From: Chris Share [cshare@sunvalley.com]
Sent: Wednesday, December 16, 2015 1:40 PM
To: Edl, Michele
Subject: Warm Springs snow melt
Attachments: photo 1.JPG; ATT00001.txt; photo 2.JPG; ATT00002.txt

From: Edl, Michele
Sent: Wednesday, October 07, 2015 10:34 AM
To: cshare@sunvalley.com
Subject: 37-8798 development work

Date: October 2, 2015
To: Water Right File 37-8798
From: Michele Edl
Re: phone conversation log

RE: Water right permit 37-8798.

1 + 88.8
Gal/m

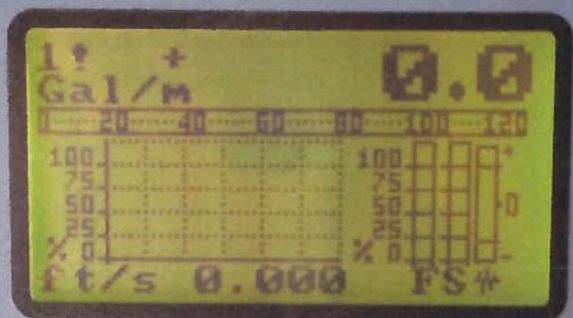
From the screen shots you have already provided, the rate for the license would be limited to 88.8 gpm. IDWR does not want to set a rate limit on the license that's too low. If 88.8 gpm is not the maximum rate you have seen, even if the higher rate is short lived, we want the license to reflect the higher instantaneous rate. We don't want Sun Valley to operate in violation of their water right, even for a short time.

> On Jul 20, 2015, at 9:37 AM, "Edl, Michele" <Michele.Edl@idwr.idaho.gov> wrote:
>
> Thanks Chris, I got these photos and they are excellent quality.
> I can see that you had the system running. Did you run the system and capture the readings at the max? or are these readings more average?
> Michele
> 208-287-4946
>
> -----Original Message-----
> From: Chris Share [<mailto:cshare@sunvalley.com>]
> Sent: Friday, July 17, 2015 7:06 PM
> To: Edl, Michele
> Subject: Water meter
>
>
>

Michele we turned on the pump and ran it for a while to make sure the cistern didn't go below our intake. Then we drove down to where the meter is and got those readings for you. Like I said before it fluctuates a little. I have seen it up to 103 gpm but it seem to settle down and stay in that mid 85 to 90 gpm. Let me know if you need anything else. Thanks Chris

TITLE: **Ball & Gosssett**
 MODEL: **P21**
 PART NUMBER: **5-408-23-080-011**
 C

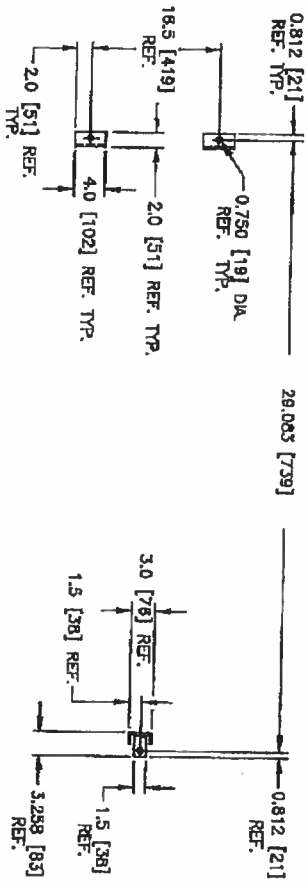
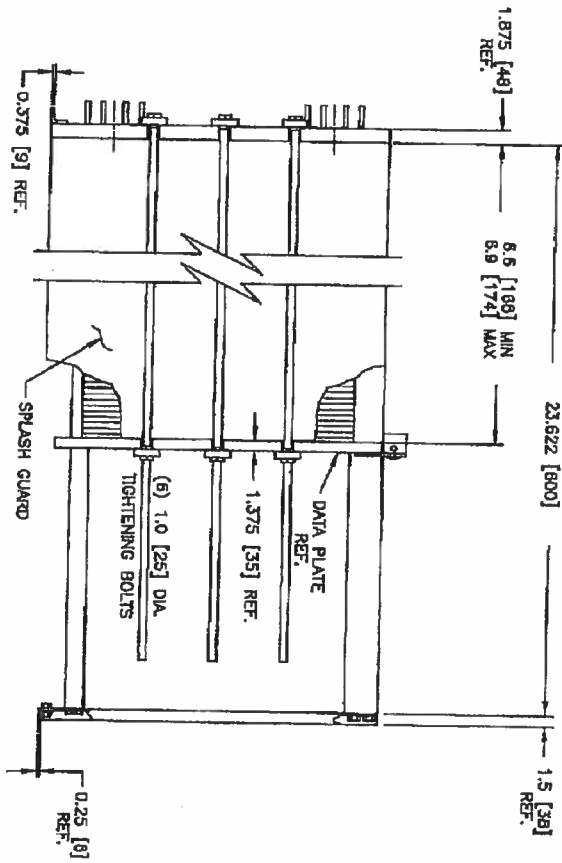
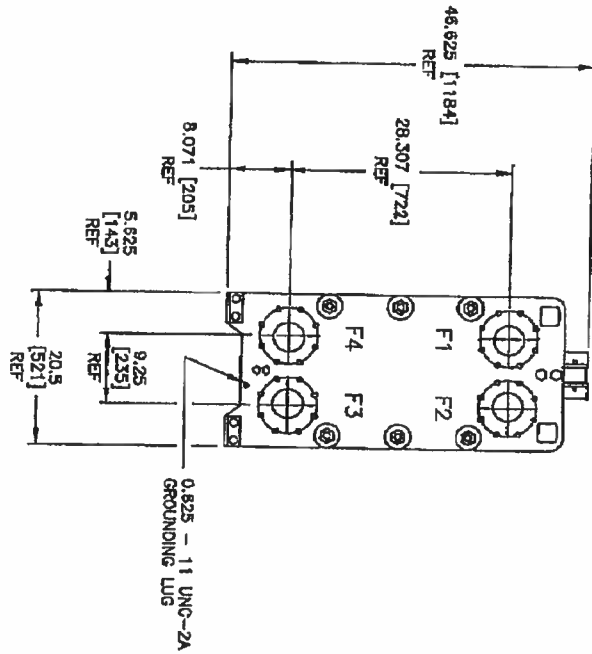
My calculations of the snow melt by this system yields a required flow rate that's a little higher than 120 gpm, the capacity of geothermal water side of the heat exchanger.

- 2) The heat exchanger appears to be able to operate on flows up to 120 gpm. To your knowledge, has it ever used as much as that?
- 3) If not 120 gpm, at what flow rate is the heat exchanger set? Notes in the file indicate a 5 hp pump is in place. Flow estimates based on the general capabilities of a 5Hp pump give a flow of 117.1 gpm. Based on our conversations, the flow rate to the heat exchanger may be set for less than that.
